SERVICE INFORMATION

STANDARD AND TRIUMPH VEHICLES

No.	SPORTS/2/P	STONE SHIELD FOR PETROL PUMP	Date	FEBRUARY 1955
------------	------------	------------------------------	-------------	---------------

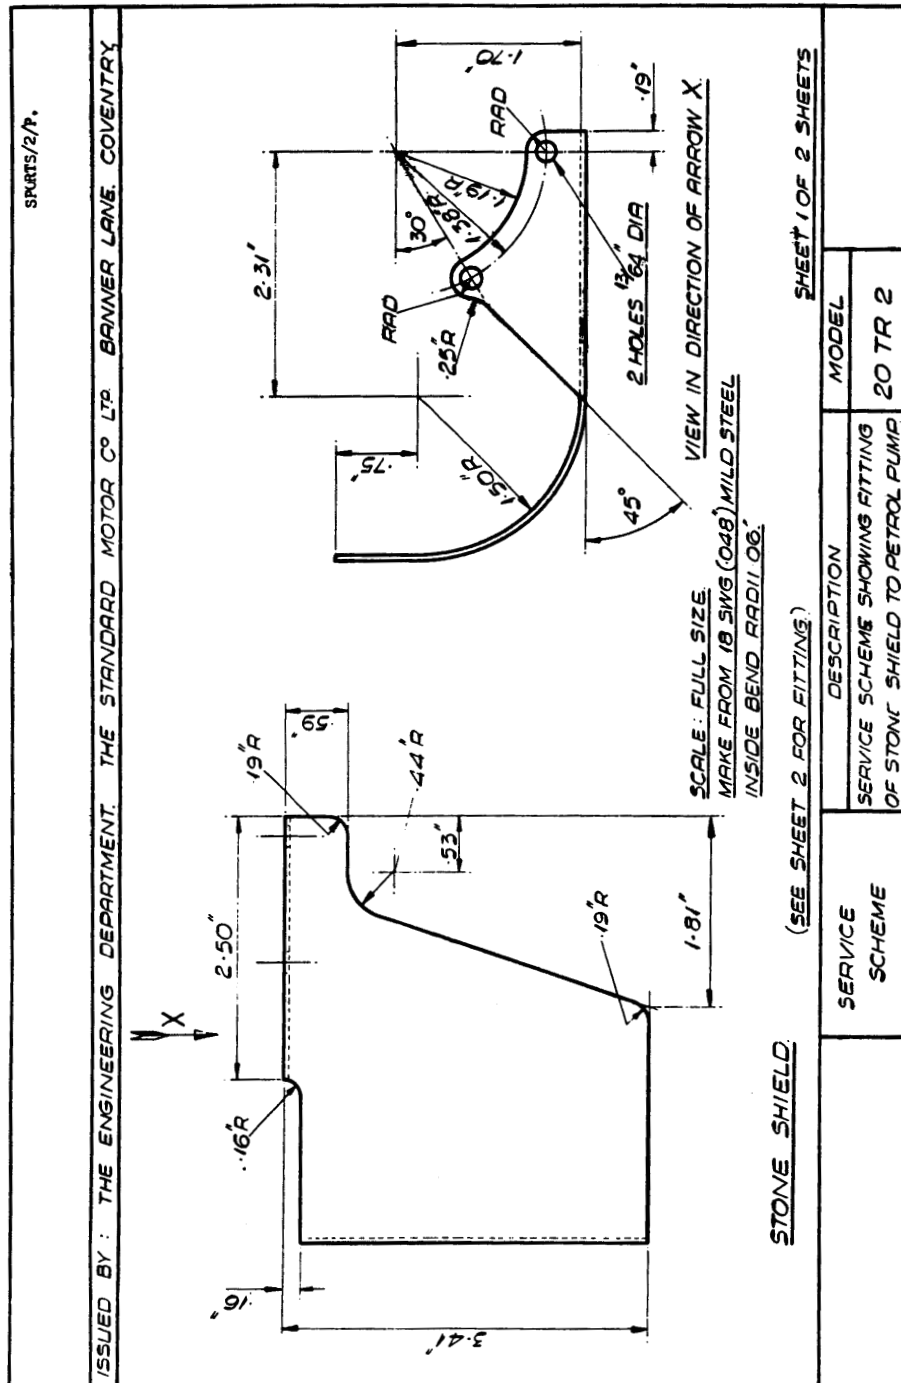
There have been one or two cases reported where the glass petrol pump bowl has been broken by a stone thrown up from the road, where such cars have been used for rally work on particularly bad road surfaces.

The attached illustrations give details for self-manufacture of a stone shield, which can be easily made and fitted.

Owners who contemplate entering the car for rally events would be well advised to fit such a shield and thus eliminate the possibility of trouble in this connection.

SPORTS 12/P.		ISSUED BY : THE ENGINEERING DEPARTMENT THE STANDARD MOTOR CO LTD BANNER LANE COVENTRY	
		<p>THE SHIELD IS FITTED TO TWO OF THE TOP COVER SECURING SCREWS AS SHOWN. THESE SCREWS ARE OF SUFFICIENT LENGTH TO ACCOMMODATE THE THICKNESS OF THE STONE SHIELD. THE SHIELD MUST BE REMOVED TO GAIN ACCESS TO THE FILTER BOWL.</p>	
STONE SHIELD IN FITTED POSITION.		SEE SHEET 1 FOR DIMMS OF STONE SHIELD	
SERVICE SCHEME		DESCRIPTION	MODEL
		SERVICE SCHEME SHOWING FITTING OF STONE SHIELD TO PETROL PUMP	20 TR 2
